# Site Analysis, Context, & Concept Southwest Neighborhood Plan

# DESIGN PROCESS

# Design Process Tie To Southwest Context and Simplify Facade

# Design Process Internal Pick Up & Drop Off

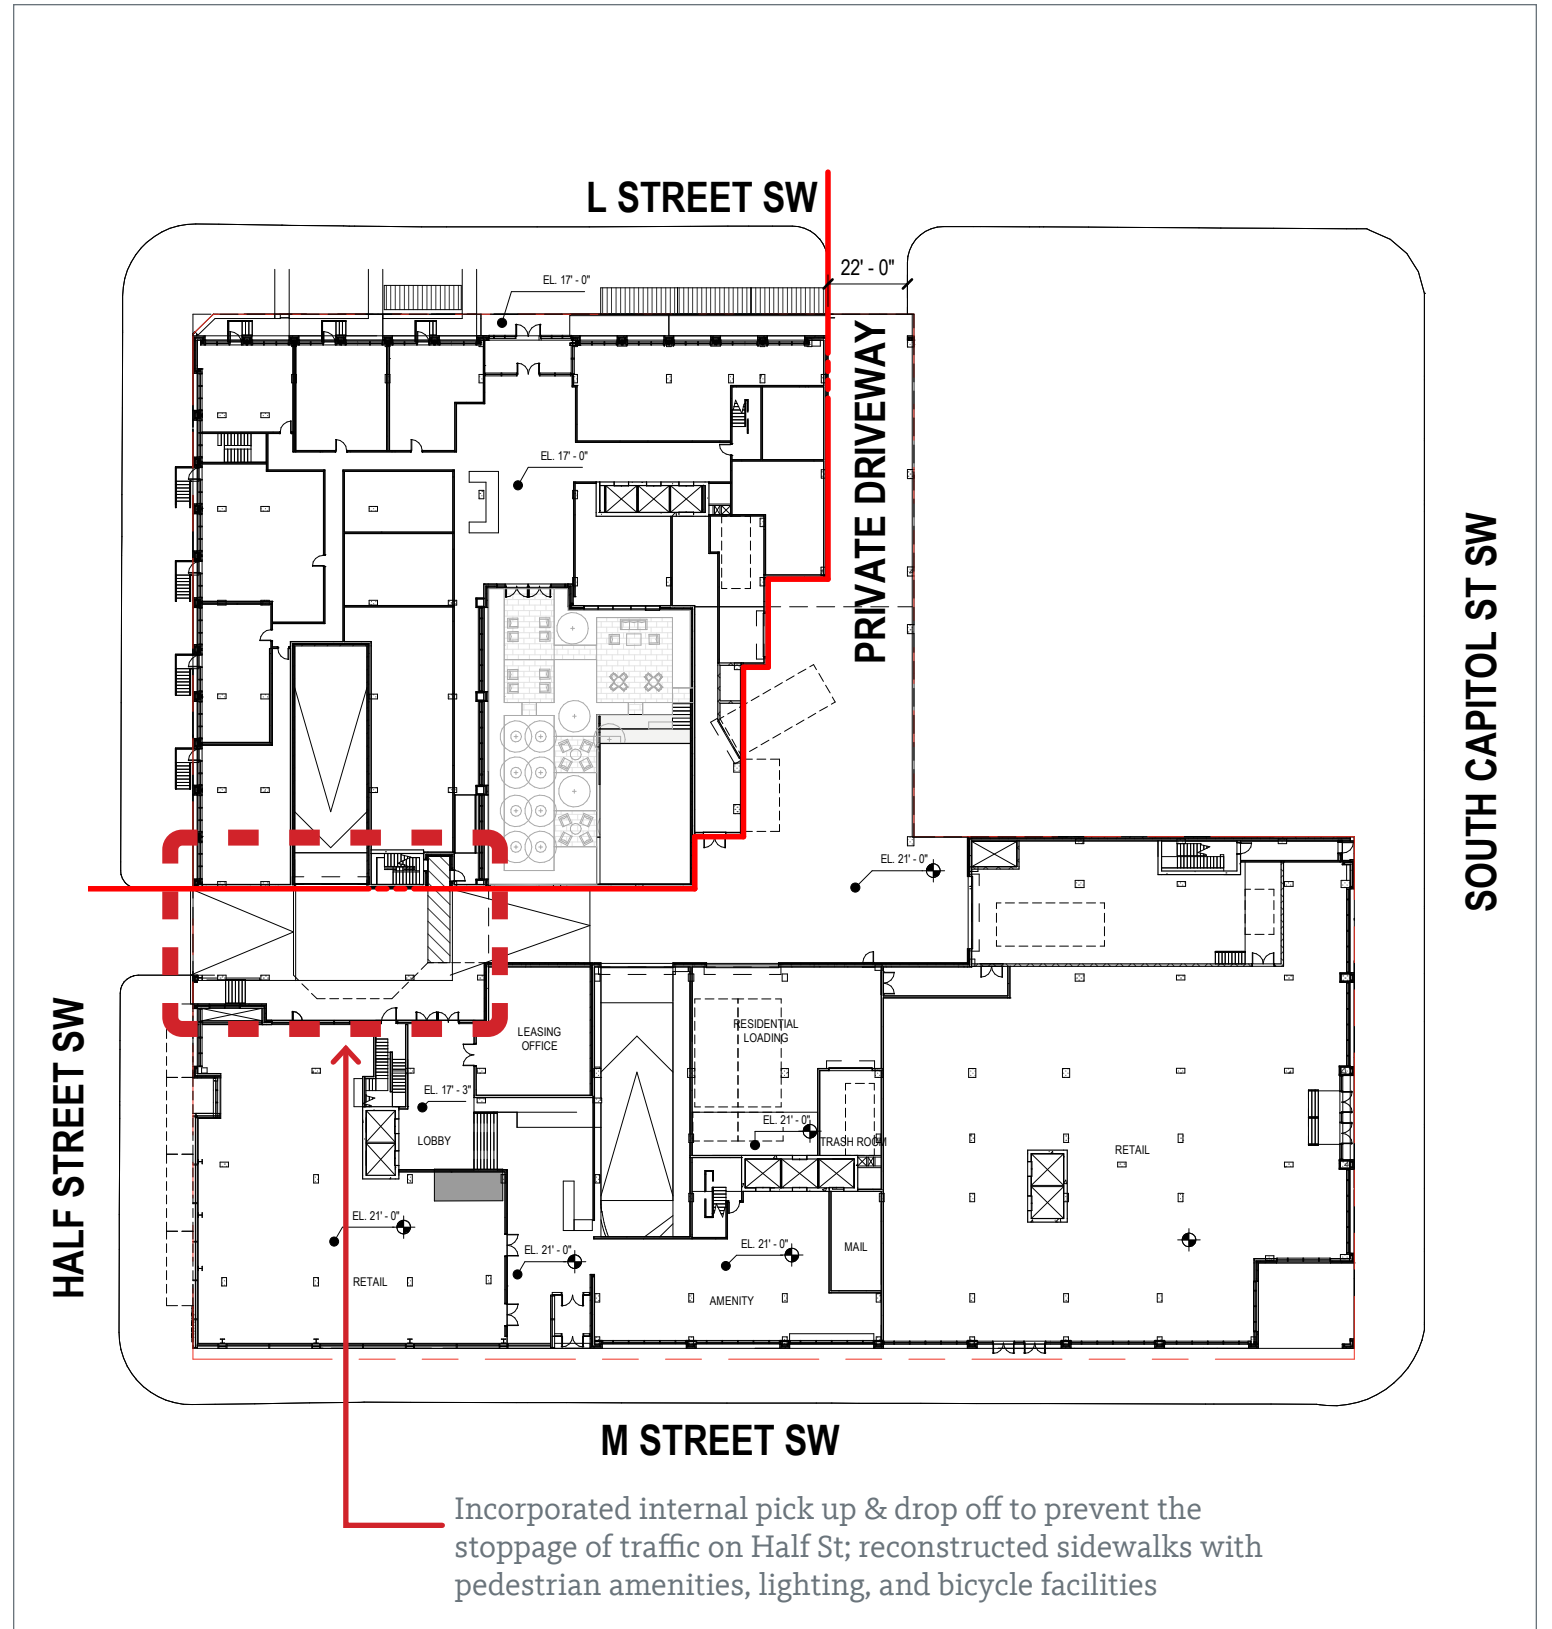
Incorporated internal pick up & drop off to prevent the stoppage of traffic on Half St; reconstructed sidewalks with pedestrian amenities, lighting, and bicycle facilities

# Redesign of Gateway Corner

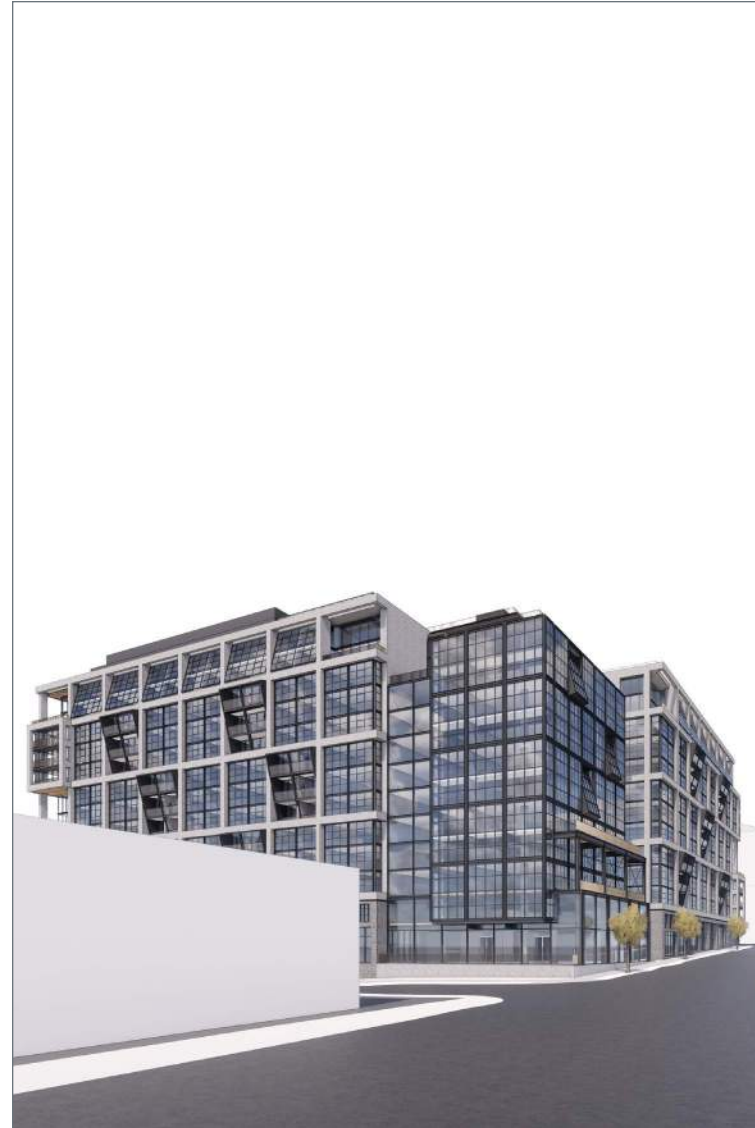
- Reduced density at southeast corner by replacing the outward-reaching interlocking bars, with inward tiering.
- Wrapped the 110' South Capitol setback around to M St SW.
- Increased podium height to balance weight of tower.
- Replaced 3-story grid with 2-story grid to reduce scale of tower.
- Introduced re-entrant corner at southeast podium corner.

- Removed all rotated ('hopper') balconies AND windows.
- Extended inset balcony design from SE corner across facades.
- Created continuous inset balcony at 10th and 11th floor to inwardly step the massing.
- Increased quantity of balconies.
- Replaced picket guardrails with glass guardrails
- Converted brick back to concrete.

## Zoning Hearing (11/12)

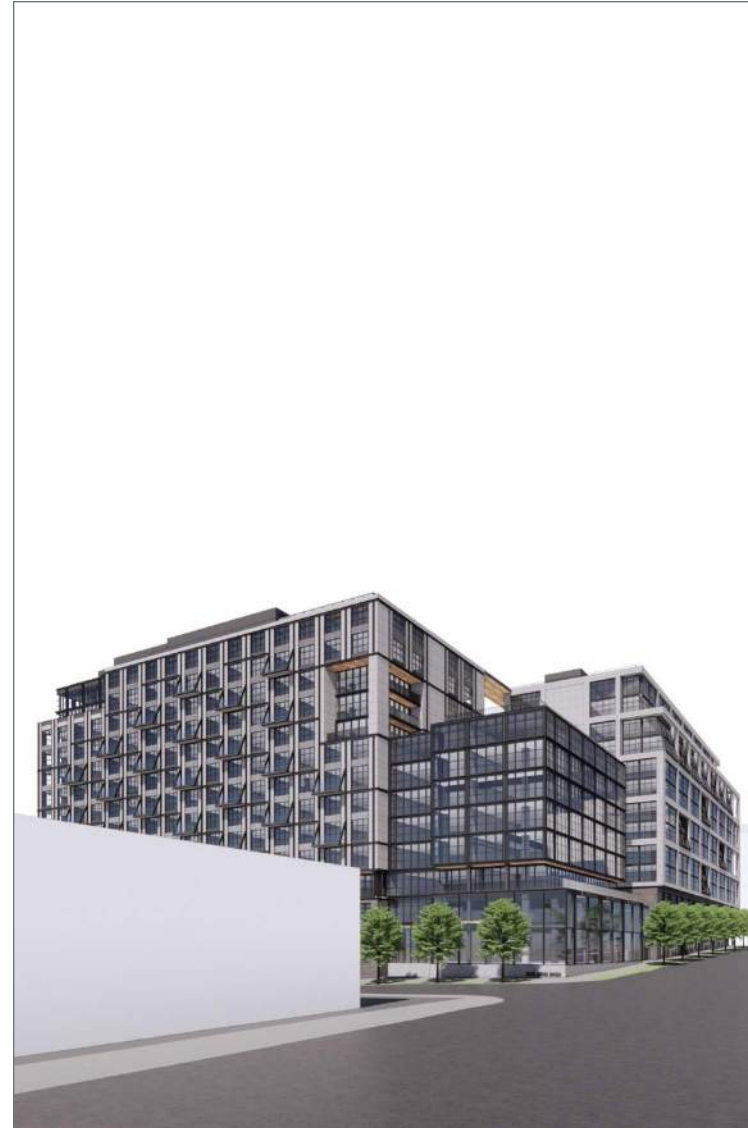
### Revised Pavilion and West Facade

- Removed the tiering of the pavilion to allow for open air porosity to courtyard.
- New brick facade type consolidated to the northwest building.
- Added balconies to west facade.
- Added 3-story inset for southern views.
- New inset corresponds with new outdoor amenity at pavilion roof.

## Current Version

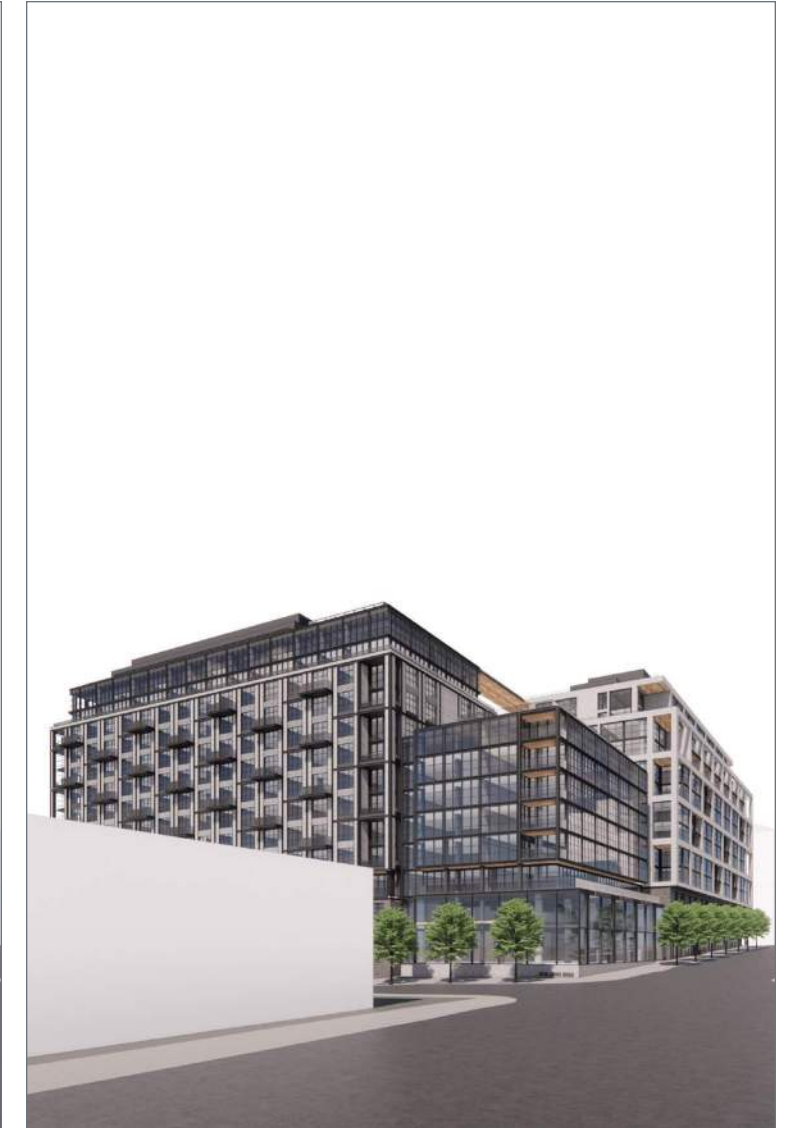
### Revised Pavilion and Northwest Tower

- Resized width and length of pavilion to simplify its relationship to towers.
- Created inset balcony at outside corner of pavilion to match outside corners of towers (added balconies).
- Created inset balcony at outside corner of northwest tower to bookend the building, and to add consistency between towers and pavilion.
- Extended tower setback to full length and width of building at levels 12 and 13.
